# Outermost Inn Modification DRI 336-M2

Land Use Planning Committee  
Dec. 12, 2022

# Outermost Inn Modification

**Location:** 18 Lighthouse Road (Map 6, Lot 32), Aquinnah

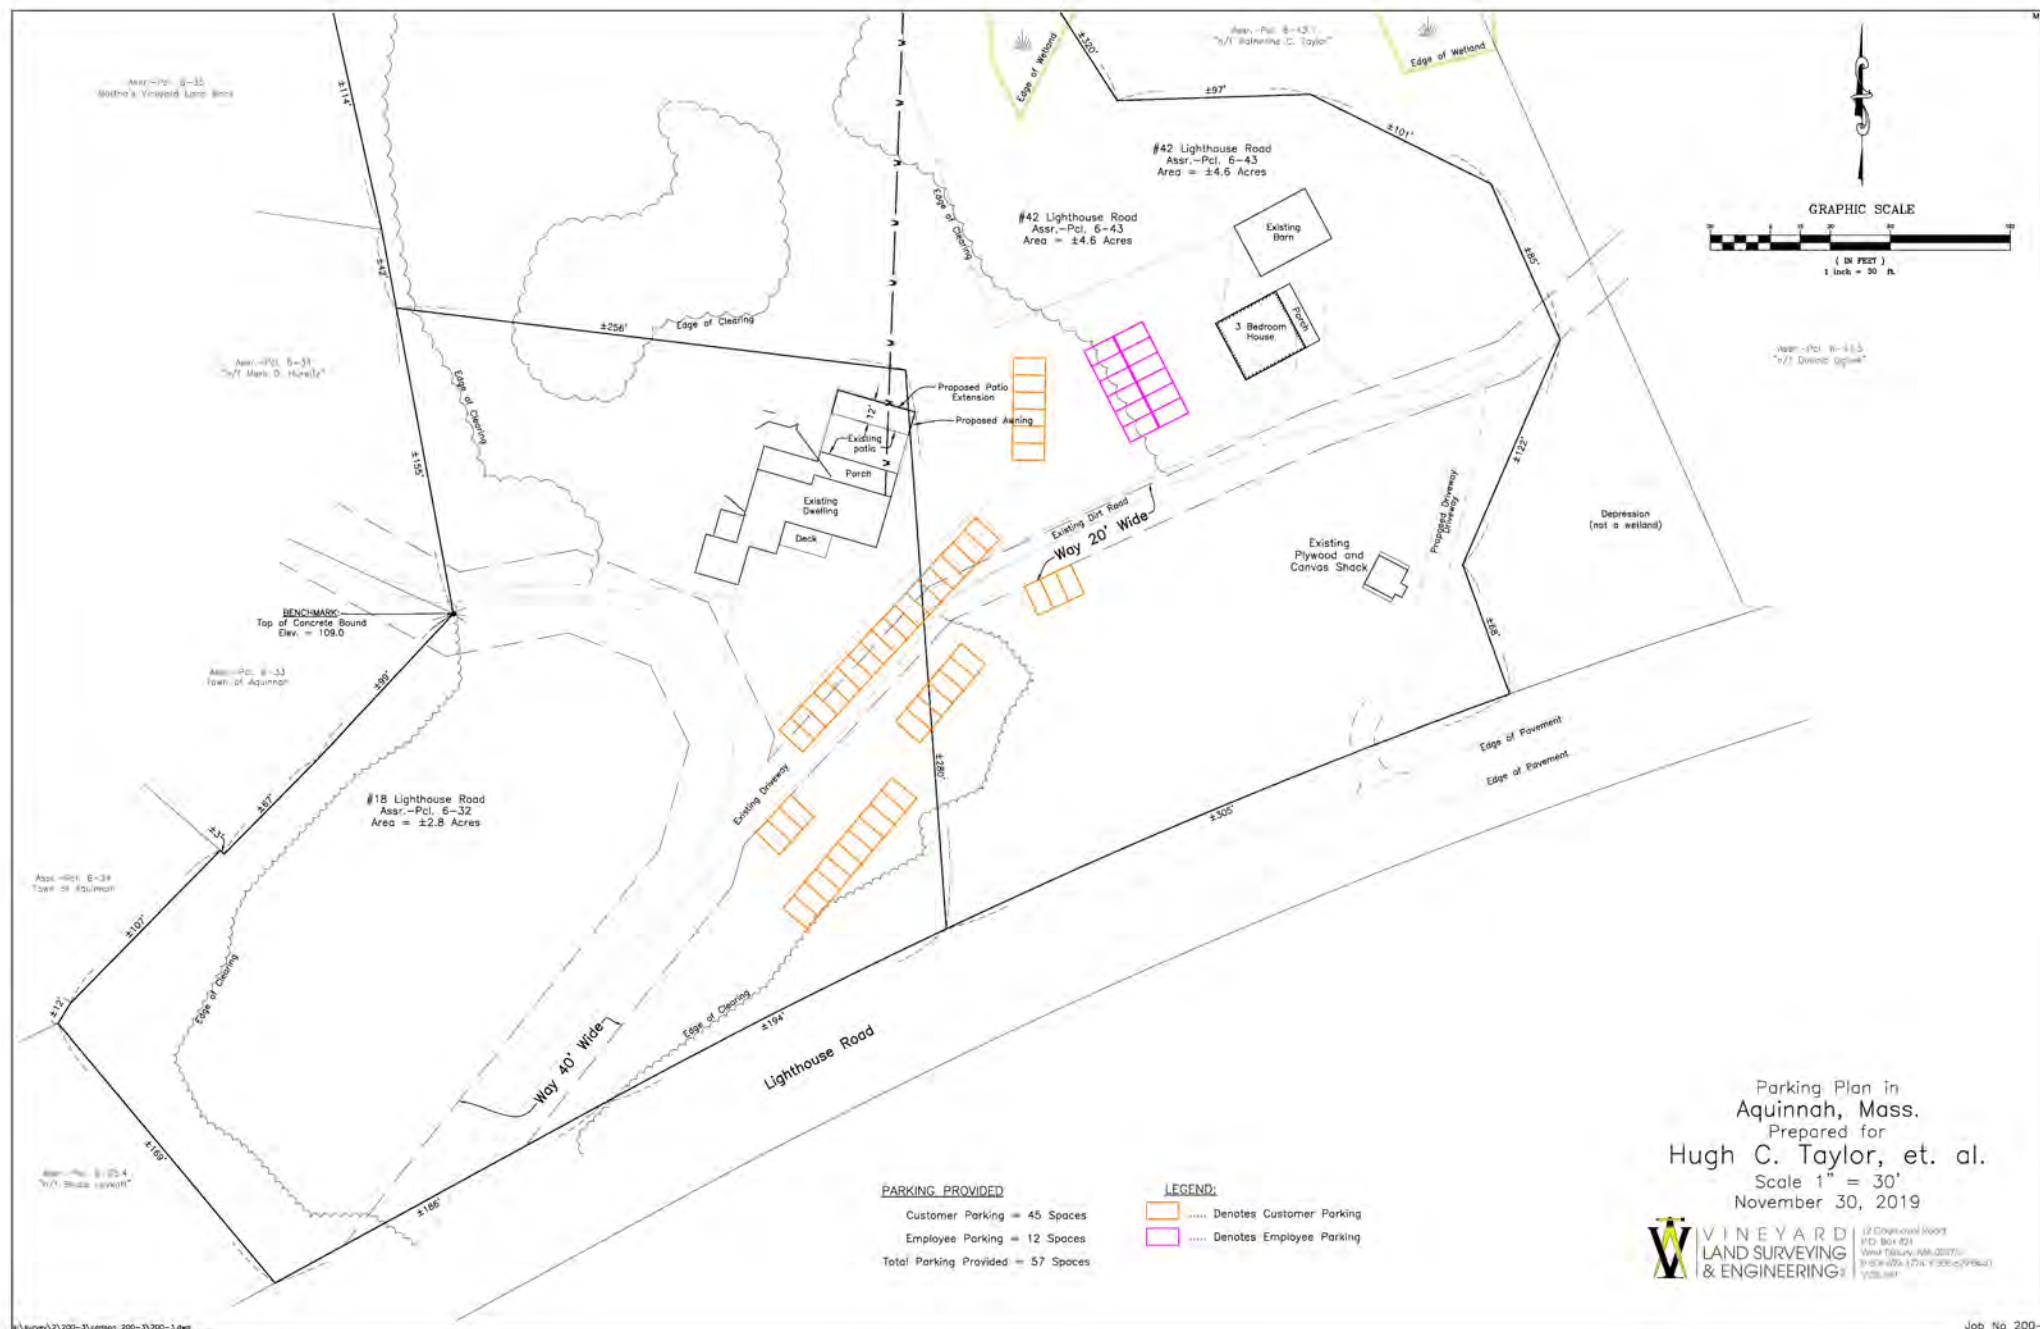
- The project is intended to make better use of existing outdoor seating at the restaurant, and the applicant has stated that it will not lead to any additional seats.
- The outdoor seating area was not reviewed by the Commission, and the seating capacity of the restaurant (including indoor and outdoor seats) has increased to more than the 34 seats allowed under the 1991 MVC decision.
- The total square footage of the kitchen and seating areas has increased from about 2,272 ft<sup>2</sup> to 3,714 ft<sup>2</sup> since 1991, and the seating capacity from 34 to 67 seats.
- The applicant has stated that the new outdoor seating area replaces some of the indoor seating, which is kept open in the event of rain.
- Parking capacity has also increased, from about 32 spaces in 1991 to 57 currently, including on the abutting lot to the east.

# Stormwater

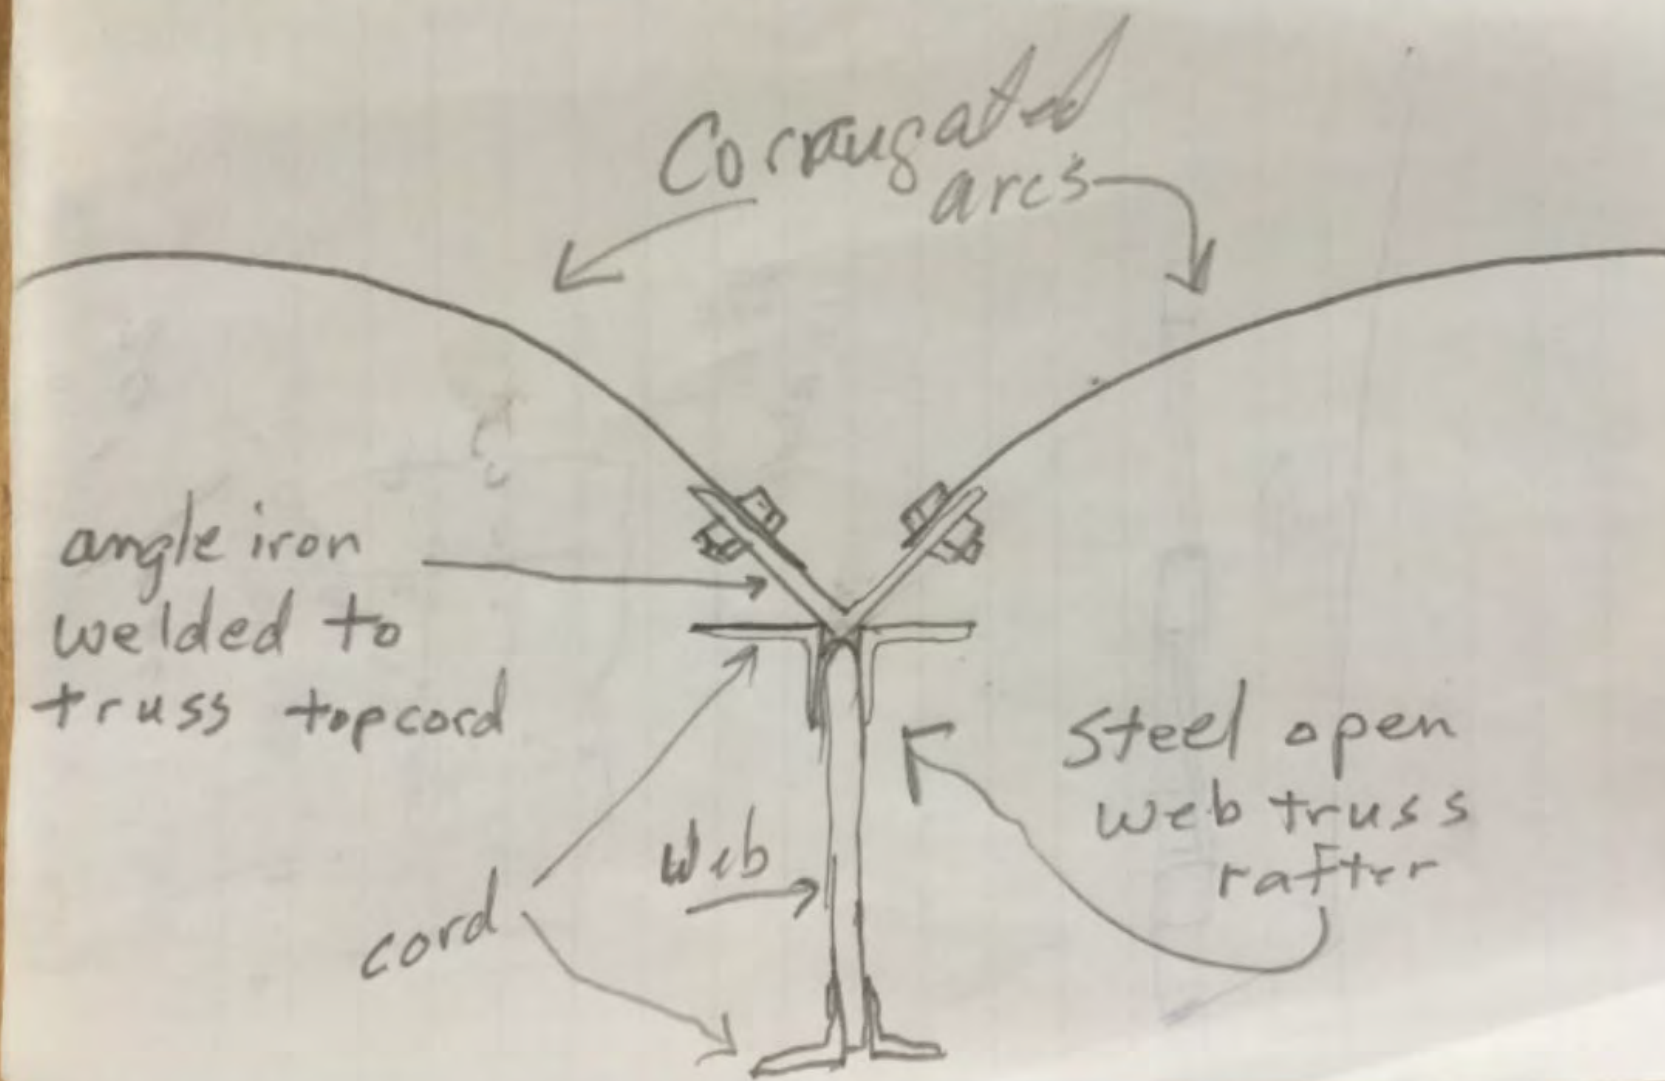
- The proposed structure would be connected to the existing building and would include V-shaped channels in the canopy that direct runoff away from the structure.
- A formal drainage plan is still pending.

PROPOSED PARTIAL NORTH ELEVATION

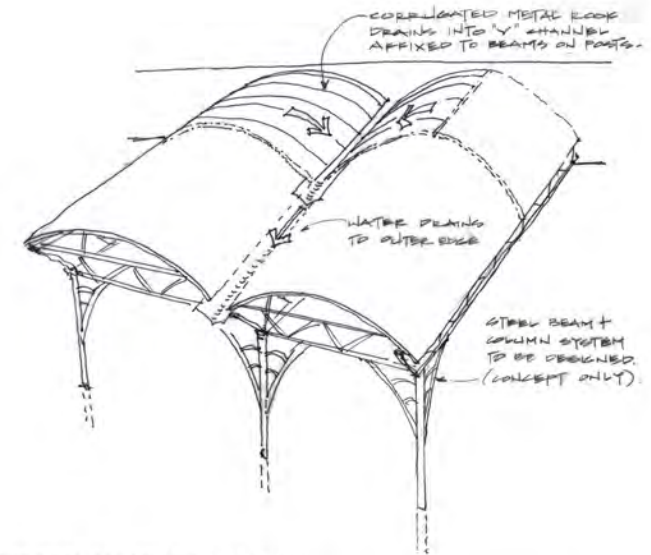
- According to the applicant, the proposed awning structure “is designed to be light in appearance, utilizing arched corrugated steel roofing to fashion a strong awning without a conventional, bulky, rafter system. We hope to achieve an open feel similar to the roof structure employed at the Tabernacle with open web steel trusses, arched bays of corrugated steel and fine steel uprights as vertical support.”
- Elevation drawings have been provided.
